Technical Service Bulletin

Mazda North American Operations
Irvine, CA 92618-2922

Subject: PART OF ACTIVE DRIVING DISPLAY IMAGE IS MISSING FROM SCREEN	Bulletin No.: 09-002/25
	Last Issued : 01/14/2025

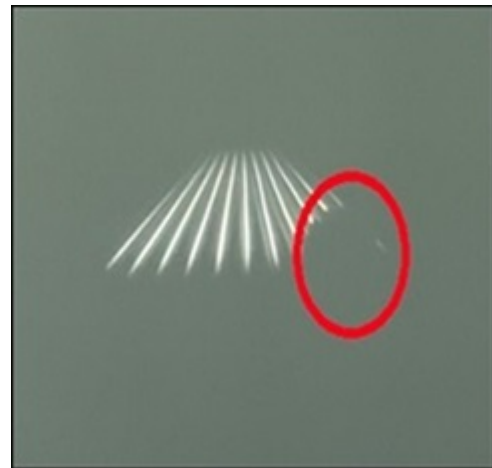
Some vehicles may exhibit a partially missing image (shown in the circles below) from the Active Driving Display (ADD) on the front window and/or display.

A circle is displayed

A part of the displayed image is missing

This concern may be caused by air entering the liquid-crystal display (LCD) of the active driving display. The moisture in the air vaporizes and forms bubbles, which appear on the image on the display. To eliminate this concern, the parts that construct the LCD have been modified to prevent water ingress.

1. Verify customer concern.
2. Replace the active driving display with the modified one according to the instructions on MGSS.
